Bunny Street

Developed design stage

Safe system audit

Report prepared for
Wellington City Council
September 2025

Figure 3-2: Bunny / Featherston / Thorndon signal phasing (note SG 1 label corrected in phase E)

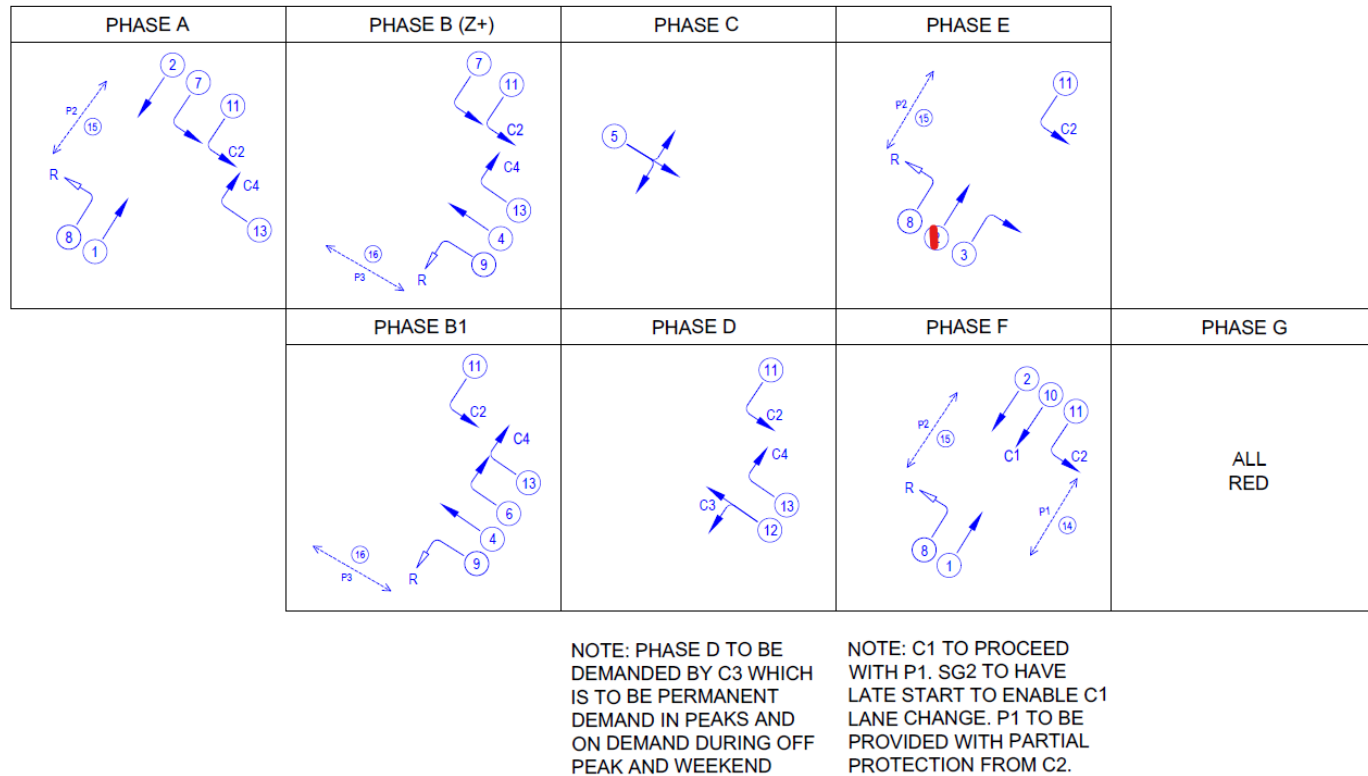
The safety issue is that cyclists travelling around the cycleway bend originating from Bunny Street (movement C4 / signal group 13) may get fed up with the stop-start nature of this movement, and progress in a phase when they have a red light. Under the proposed phasing (Figure 3-2): - Phase A – C4 can go - Phase B – C4 can go - Phase C – C4 red light (presumably to avoid conflict with cyclists coming from Bunny St west approach and entering the cycleway) - Phase D – C4 can go - Phase E – C4 red light (to avoid conflict with cyclists coming from the Thorndon Quay cycleway approach and progressing through the intersection) - Phase F – C4 red light (to avoid conflict with crossing pedestrians) I.e. there are three times in a cycle where C4 cyclists are expected to stop, of which only one (Phase F) is probably warranted.	Probability of crash occurring	Unlikely
	Expected crash severity	Minor injury

Primary treatment recommendations:	
	3.1.5.1	N/A
	Supporting treatment recommendations:	
	3.1.5.2	Swap the phasing order to A-B-D-C-E-F. That way, there would only be one period when the C4 movement has to stop.
The crash types expected is cyclist vs cyclist. The risk factors include: Expected low volumes of cyclist coming from Bunny St west in Phase C – therefore conflict of risk is rare and frequent cycleway users may get used to continuing during this phase, putting them at risk when cyclists do come from Bunny St west. (This could also be a risk for the C2 movement). The corresponding cycleway bend movement coming from Thorndon Quay (C2) operates in Phase E; C4 cyclists seeing this may assume they can also go.		
Responses:

Designer	For phase C SG13 was not included because it conflicts with cyclists going Bunny St west to Bunny St east. It is acknowledged that this movement is low volume and is good sightlines. However adding SG13 would mean that cyclists would receive a green right turn arrow (positive confirmation of priority) but would need to give way to cyclists going straight. This phasing is not TCD compliant but there is a low safety risk. For phase E SG13 was excluded because of the cycle movement from Stout St to Thorndon Quay which is high volume in the afternoon peak, is high speed due to 34m clearance distance and cyclists would not be expecting to check to their left when turning right. Would not want to run SG13 in phase E for these reasons. Agree with reordering phases to align SG 13 movements. SG13 would receive approx. 85 sec green time out of 120 sec in morning peak under typical phase lengths of A, B and D (phase C runs infrequently) this is 70% green time which is excellent LOS.

Safety Engineer	Agree with Designer's response. Max CL for the intersection would be 110s instead of 120s. Same requirements for detailed design as in 4.1.1 and 4.1.2 Safety Engineer comments.
Client	Agree with responses above
Action	Address in detailed design

Figure 3-4: Thorndon Quay approach primary signals

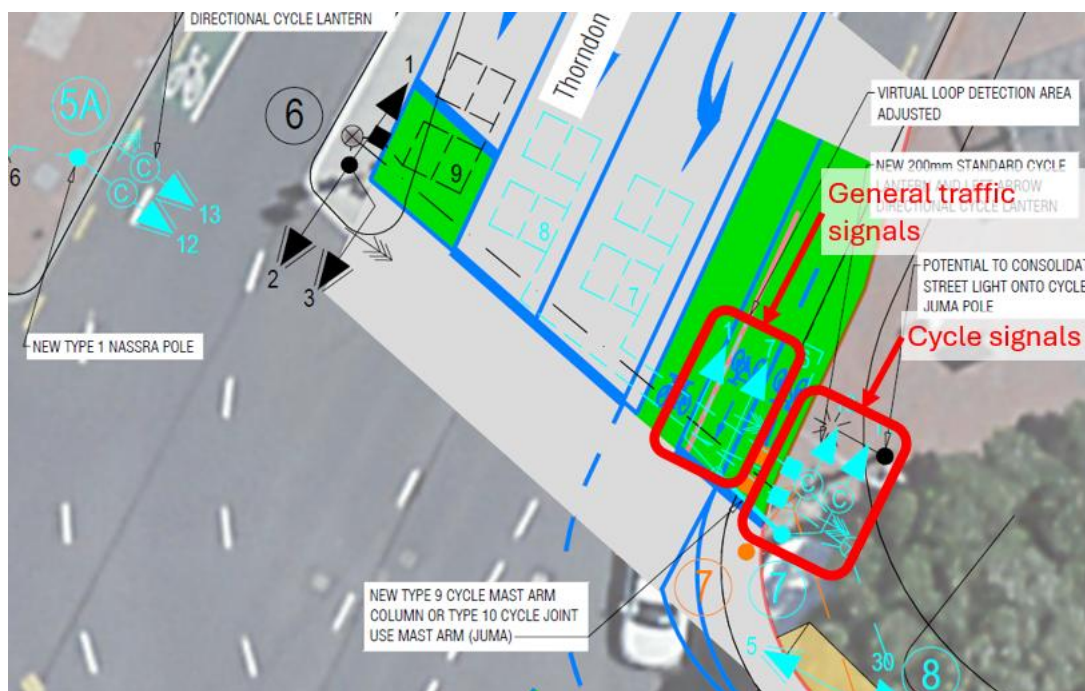
The safety issue is that cyclists entering the road from the Bunny Street cycleway approach might think the signals for the cycleway bend (SG 13 – see Figure 3-2) in the primary position (i.e. at the limit line) apply to them, and proceed during the wrong phase. The crash type expected is cyclist vs motor vehicle – depending on the phasing, the latter could be travelling at speeds likely to cause serious injury to a cyclist. The risk factors include: - Both columns of cycle signals (“standard” i.e. non-directional, and right turn) are located directly to the left of the cycleway approach lane for road-entering cyclists – meaning the signal column immediately adjacent to these cyclists is in fact the signal column for the cyclists continuing around the cycleway bend. - Potential for primary cycle signals to be mounted at lower height, thus potentially visible to waiting cyclists. - General lack of familiarity with directional cycle signals / multiple cycle signal columns for a signal approach. - People react to change – even if they understand the difference between the two cycle signals, road-entering cyclists may make a false start when they see SG 13 go green. - Compounding effects with other issues discussed in issues 3.1.3 and 3.1.4	Expected crash severity	Serious injury

Primary treatment recommendations:	
	3.1.2.1	Separate the two cycle signal columns on the Bunny St cycleway approach, so that each clearly relates to a specific cycle lane – the best way to achieve this is likely to be a gantry over the cycleway.

3.1.2.2	Provide more logical positioning of the general traffic vs cycleway signals on the Thorndon Quay approach – locate the general traffic signals as close to the general traffic lanes as possible (i.e. allowing for clearances to heavy vehicles) and locate the cycle signals above their respective cycleway lanes.
	Supporting treatment recommendations:

For the Thorndon Quay cycleway approach, the signals would be located next to the cycleway bend approach lane, and these cyclists would only face the risk of not proceeding when they are actually able to, which has no risk of conflict with motor traffic. Furthermore, while road-entering cyclists would have to look over

the adjacent cycleway lane to see their signals, the closest column to them would be the column relating to their movement. However, it appears that the general traffic signals would be located on a mast-arm with two columns located in a central position above the cycleway approach lanes (Figure 3-4), which could cause extra confusion for cyclists and result in them progressing when there is a green for general traffic but not for a cycleway movement.

Concerns noted. Proposed design changes is to relocate the Thorndon Quay primary vehicle lanterns to an island between the traffic lane and cycleway. This would involve replacing a section of cycleway dividers with a 1.1m wide traffic island which provides sufficient clearance for a two column lantern. The cycleway would be narrowed to a 1.5m wide departure lane and two 1.25m wide approach lanes (no islands between cycleway lanes). A type 9 cycle mast arm column or type 10 cycle joint use mast arm would be located in the footpath (as previously proposed). A left turn cycle directional lantern would be mounted to the upright and a standard cycle lantern would be mounted on the outreach.

For the Bunny St approach the proposed design changes to use a type 9 cycle mast arm column with the standard cycle lantern mounted on the upright and the right turn lantern located on the outreach. This would place the right turn directional cycle lantern over the right turn cycle lane.

Safety Engineer	Agree to separate SG12 and SG13 lanterns and install a cycle outreach so that SG13 is over its lane. Install outreach for TQ cycleway as well. 5m mast arm outreach for TQ vehicles. Revised detailed design is to be provided to the Safety Engineer and Traffic Signals team to review and approve if the proposed changes are acceptable. The revised detailed design is to include the layout from kerb to kerb to understand the overall impact on this major transport corridor.
Client	Agree with responses and detail to be confirmed in the details design stage
Action	Confirm at detailed design review.

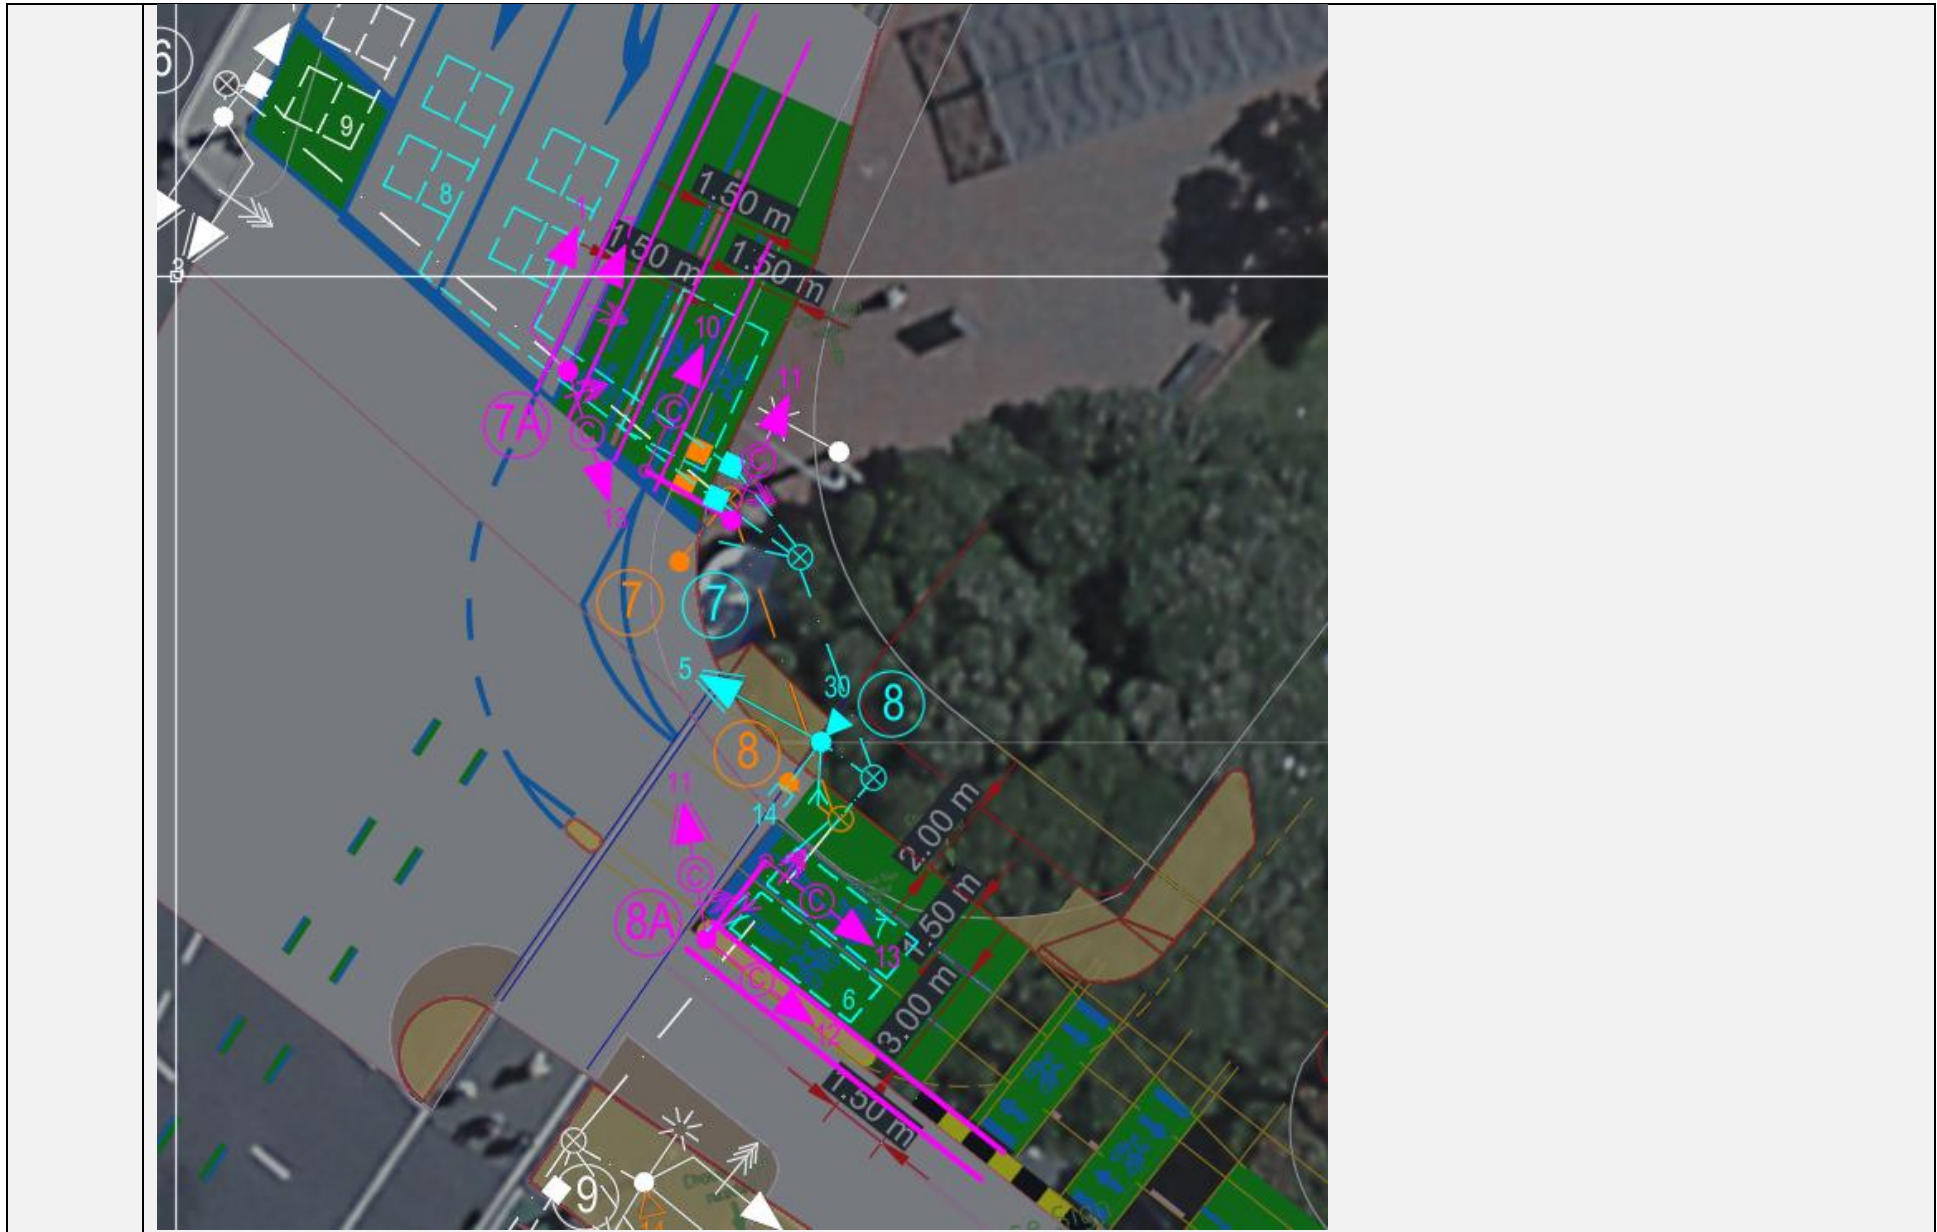
The safety issue is that cyclists entering the road from the Bunny Street or Thorndon Quay cycleway approaches might think the signals for the cycleway bend (SG 10 / SG 13) in the far-side position (i.e. on the departure side of the intersection) apply to them, and proceed during the wrong phase. The crash type expected is cyclist vs motor vehicle – depending on the phasing, the latter could be travelling at speeds likely to cause serious injury to a cyclist. The risk factors include: - Both columns of cycle signals (those for cyclists entering the road and progressing across the intersection, plus those for cyclists continuing around the cycleway bend) are located on the same pole on the departure side of the intersection, which means: - cyclists continuing on the cycleway will probably not be looking in the direction of the far-side cycle signals, since they will be turning a short corner and not progressing across the intersection; and - the far-side signals appear as if both columns are for cyclists entering the intersection; this is a particular concern for cyclists on the Bunny St on-road cycle lane or road-entering cycleway approaches who are planning on turning right onto the northbound on-road cycle lane on Thorndon Quay. - General lack of familiarity with directional cycle signals / multiple cycle signal columns for a signal approach. - People react to change – even if they understand the difference between the two cycle signals, road-entering cyclists may make a false start when they see SG 10 / SG 13 go green. - Compounding effects with other issues discussed in issues 3.1.2 and 3.1.4.	Probability of crash occurring	Unlikely

Expected crash severity	Serious injury
	Primary treatment recommendations:	
	3.1.3.1	Do not locate the far-side signals for the short-turn cycleway bend movements on the far-side of the intersection.

3.1.3.2	Consider whether they can be mounted on the departure side of the cycleway. This will be more feasible for the Thorndon – Bunny direction, as a signal pole could be located on the kerb. For the Bunny – Thorndon direction, consider whether an additional signal pole could be accommodated in the separator between the cycleway and the left-turn general traffic lane.
	Supporting treatment recommendations:

Designer	Concerns noted, proposed design changes are: • Mount far side SG11 lantern on new pole 8A in the island between traffic lane and cycleway which is visible to cyclists turning left. This leaves the SG10 cycle lantern on pole 1 for cyclists travelling to Featherston St • Mount far side SG 13 lantern on a new standard pole between the traffic lane and cycleway which is immediately behind the departure side cycle lane for cyclists turning right into Thorndon Quay. This leaves the SG12 cycle lantern on pole 5A for cyclists going to Bunny St west
-----------------	--

Safety Engineer	Agree with designer response. Same requirements on the review of detailed design as in 3.1.1 and 3.1.2 Safety Engineer comments.
Client	Agree with above responses
Action	To be updated in detailed design

Figure 3-8: Proposed marking additions at pedestrian-cycle conflict point

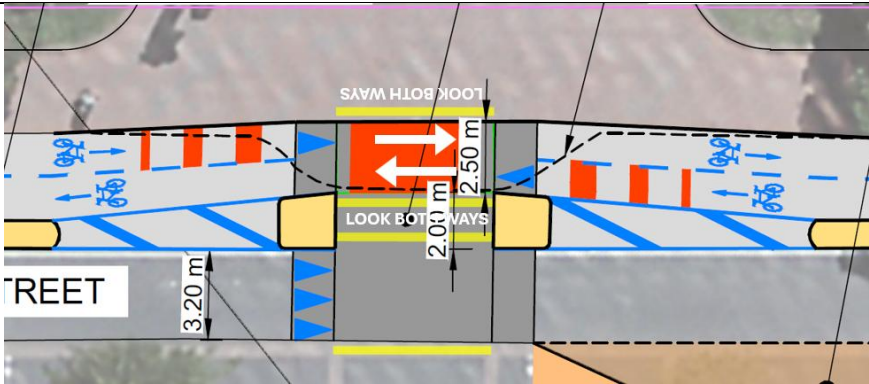
The safety issue is that pedestrians crossing the two-way cycleway on Bunny Street may not expect cyclists to be coming from the contra-flow direction. The crash type expected is pedestrian vs cyclist. The risk factors include: • In this location, pedestrians only have to think about one direction of general traffic at a time, and would likely expect cyclists to be coming from the same direction as the general traffic. • Two-way on-road cycleways of this nature are reasonably rare in Wellington. • High cycle and pedestrian volumes. There is little guidance relating to providing for pedestrians crossing two-way cycleways; however, there is guidance regarding drawing motorists’ attention to looking both ways when crossing two-way cycleways at driveways or side streets – specifically the CNG technical note: High-use driveway treatment for cycle paths and shared paths. The proposed plans already cover one important element – contrasting colour, but would benefit from using directional arrows.	Probability of crash occurring		Unlikely

Expected crash severity		Minor injury
	Primary treatment recommendations:		
	3.2.2.1	N/A	
	Supporting treatment recommendations:		
	3.2.2.2	Add arrows showing cycleway directions across the pedestrian crossing (see Figure 3-8).

3.2.2.3	Add “look both ways” markings approaching the conflict point (see Figure 3-8).

Responses:	
Designer	Agree with recommendations.
Safety Engineer	Agree with Designer response.
Client	Agree with responses.
Action	Addressed in final Developed Design.

Figure 3-10: Vehicles anticipated to block cycleway approaching Featherston St

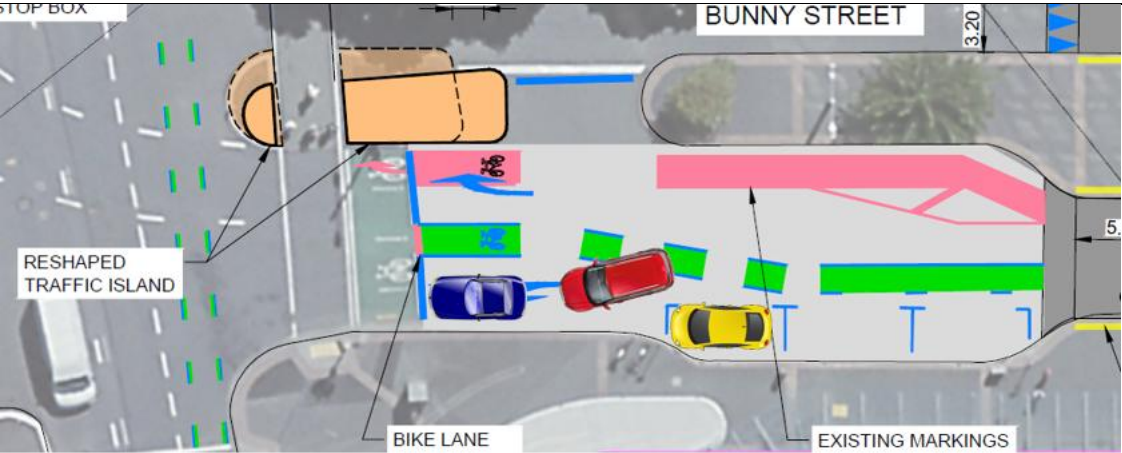
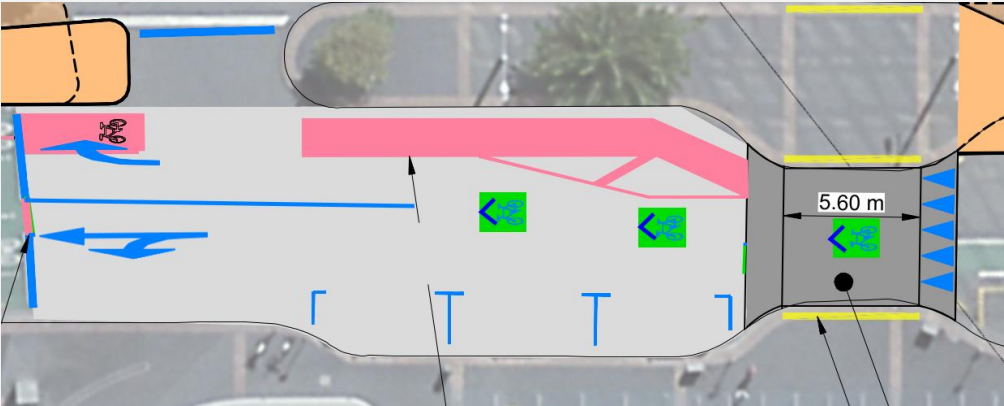
The safety issue is that vehicles in the shared left-turn / through lane on the Bunny Street east approach are likely to hang over the cycle lane, forcing cyclists into the general traffic lane (see Figure 3-10). The crash type expected is motor vehicle vs cyclist. The risk factors include: - Traffic volumes for the left-turn and through movements (unknown to the SSAT) - Likely presence of parked vehicles in the adjacent kerbside parking spaces - Tight turning geometry for vehicles entering the left-turn / through lane - Short storage space in the left-turn / through lane - Potential for drivers to be rushing to catch a green light	Probability of crash occurring		Unlikely
	Expected crash severity		Minor injury
	Primary treatment recommendations:

3.2.4.1	N/A	
	Supporting treatment recommendations:		
	3.2.4.2	Begin the cycle lane taper earlier (i.e. further east), corresponding with the widening of the traffic lanes, to achieve more clearance between the cycle lane and the left-turn / through lane.

Concerns noted, as per above, the intention is to remove the marked westbound cycle lane on Bunny Street west of the platform as shown indicatively below.

Figure 3-11: Missing physical separation in vicinity of pedestrian crossing

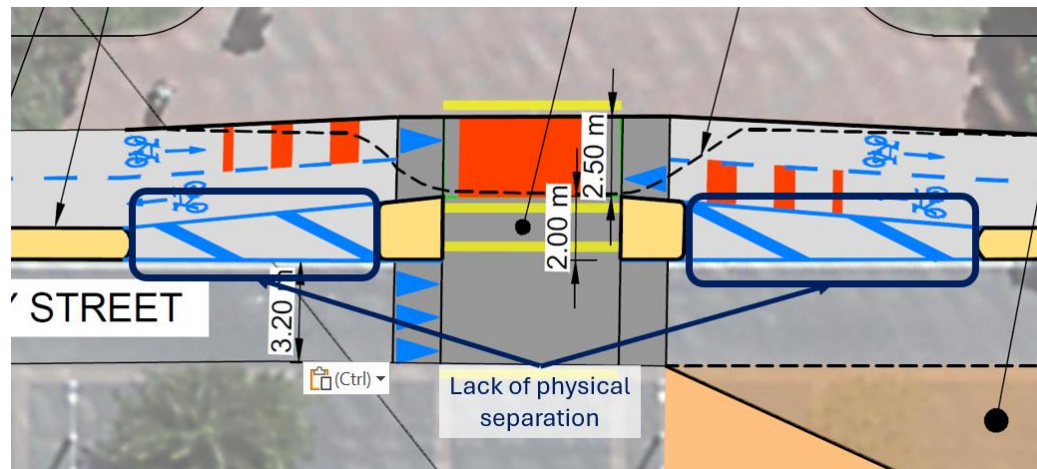
The safety issue is that there are gaps in the physical separation on the Bunny Street cycleway, which could encourage motor vehicles to inadvertently enter the cycleway or attempt to park there (see Figure 3-11).

- High volumes of taxi / uber drivers in the vicinity of the Railway Station
- Reduced taxi parking in the taxi loop
- Limited on-street parking availability

Designer	Agree with parking concern, can add broken yellow lines to hatch area. Previous concern raised about pedestrians tripping on cycleway separator which is why a section of cycleway separator was removed from the design
Safety Engineer	Agree with Designer response.
Client	Agree with responses.
Action	Addressed in final Developed Design.

Figure 3-12: Confusing left-turn arrow approaching taxi loop exit

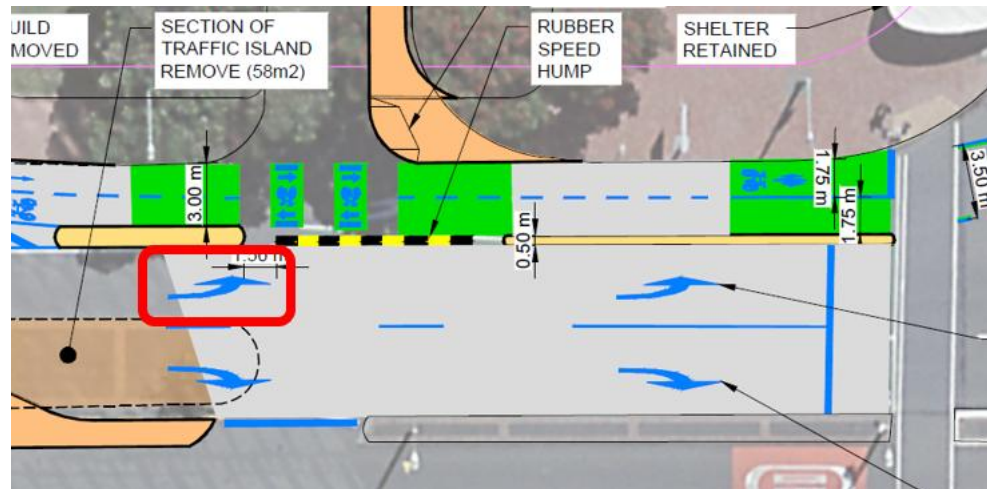
The safety issue is that drivers on Bunny Street might try to turn into the taxi loop exit, due to the positioning of the left-turn arrow marking (see Figure 3-12)

- Left-turn arrow located directly near the taxi loop exit, meaning it could be mistaken as denoting a turn into the exit.
- Lack of painted arrow or “NO ENTRY” text on the taxi loop exit
- “No-entry” signs on taxi loop exit obscured by large trees
- Two-way cycleway; drivers not expecting cyclists in the contra-flow direction, increased cognitive demands.

Probability of crash occurring	Likely
Expected crash severity	Minor injury
Primary treatment recommendations:	
3.2.6.1	Relocate the two left-turn arrows further forward.
Supporting treatment recommendations:	
3.2.6.2	Forgo the initial lane arrows – they are not needed for this short lane length, especially given the lower vehicle operating speeds.
3.2.6.3	Add painted arrow and “NO ENTRY” text on the taxi loop exit.
3.2.6.4	Bring the “NO ENTRY” signs forward of the trees and ensure they are sufficiently visible.
3.2.6.5	Despite the fact that the black and yellow speed hump should technically only be required on the taxi loop exit side (see issue 3.2.7) retain the one proposed on the Bunny Street side as well. The SSAT considers that removing the speed hump in this location would make the prohibited turn into the taxi exit look more “inviting” compared with installing it.

Responses:	
Designer	Agree with recommendations.
Safety Engineer	Agree with Designer response.
Client	Agree with responses.
Action	Addressed in final Developed Designs.
